service bulletin

M86-11 Rev. 1
Supersedes M86-11Technical Portions Are
FAA Approved

SUBJECT: CONNECTING ROD PRODUCT IMPROVEMENT**COMPLIANCE:** At Next Engine Overhaul, Top Overhaul, or Anytime Cylinders are Removed For Any Reason

FIGURE 1. CONNECTING ROD.

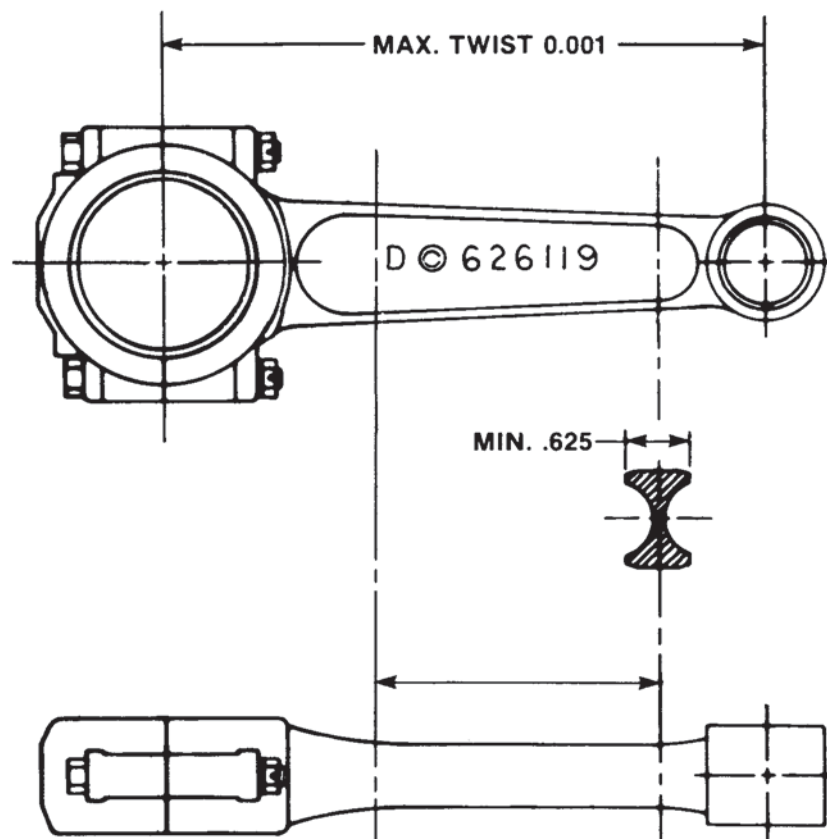
We recommend that at any time access is gained to the connecting rods during cylinder removal, the beam section dimension of the connecting rods with forging number 626119 be measured as per illustration Figure 1, and also as found in Overhaul Manual X30030A. Any connecting rod below .625 dimension should be replaced with a new product improvement connecting rod with additional margin of safety, P/N 646321 or P/N 646320, depending on the model affected. In addition, it is recommended that published operating and maintenance procedures be strictly followed to prevent the causes of excessive cylinder pressure as noted in the preceeding paragraph.

NOTE: THIS INSPECTION PERTAINS TO THE 626119 FORGING ONLY
